SCOTCHMER & BEST STREETS DEVELOPMENT PROPOSAL PLN170618 WHAT IS PROPOSED

This is a guide intended to help interested community members to understand what is proposed. It includes some of the concerns that have been raised about the proposal. However, it is up to you to determine what the proposal means to you.

from this ... to this...

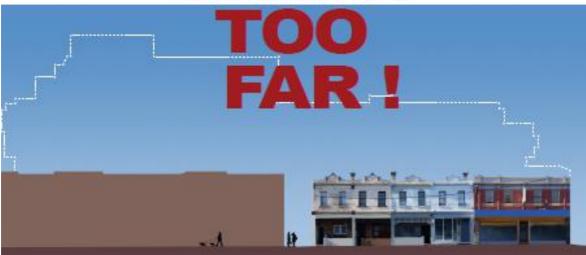
- The proposed building will be 7 storeys high. This significant scale is at odds with the neighbourhood character which is largely one and two story dwellings and retails, and is inconsistent with the requirement by Heritage Overlays and planning policy.

- Demolition of the majority of current heritage buildings and replacement with construction of a new 7 storey building. This is counter to good practice for retention of heritage buildings.

- The proposed built form above the existing heritage facades will dominate the streetscape.
- 3 metres of the existing facade of the warehouse in Scotchmer and Egremont Streets is to be retained. This is contrary to the objectives of the heritage overlay.

- The architectural styles of the upper five storeys of the proposed building are out of context to the area and inappropriate in Fitzroy North e.g. use of mansard roofs, boxed dormer windows and the use of wedding cake tiering.
